Planning Commission Minutes
October 13, 2022

13. (SPUD-1447) Application by R7 Capital Funding, LLC., to rezone 1900 NW 10th Street from the R-2 Medium-Low Density Residential District to the SPUD-1447 Simplified Planned Unit Development District. Ward 6.

STAFF REPORT
The City of Oklahoma City
Planning Commission
October 13, 2022

Item No. IV. 13.

SITE PLAN - CONCEPTUAL DEVELOPMENT - OPTION A

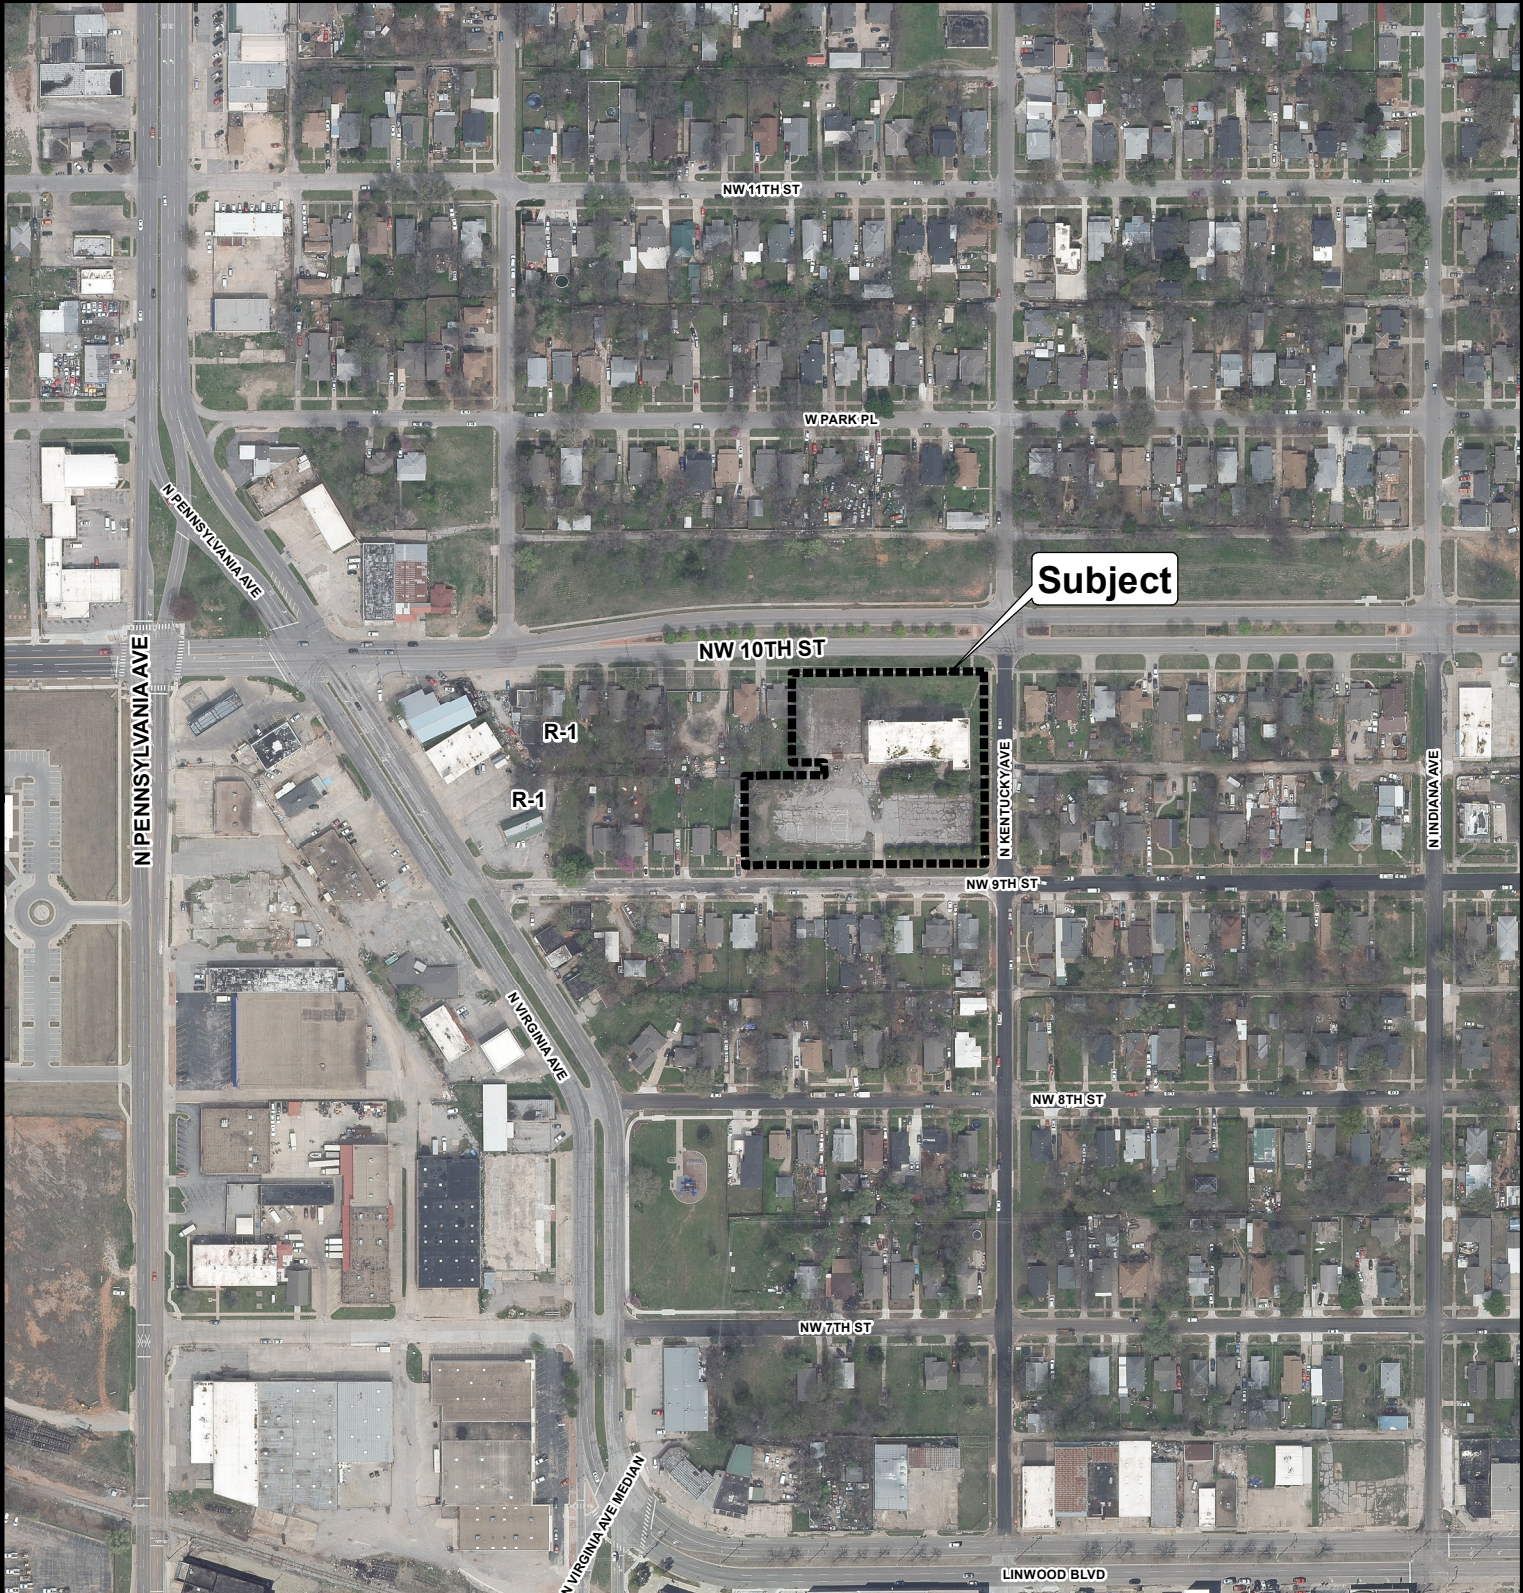
The subject site has one improved drive along NW 9th Street and no access points on NW 10th Street or N Kentucky Avenue. The SPUD Master Design Statement would allow access from all streets, although the conceptual design indicates the existing driveway would be the only one and used to access the parking on the south. Plan conformance would be strengthened by prohibiting driveways on NW 10th Street.

1. No new driveways shall be permitted on NW 10th Street.
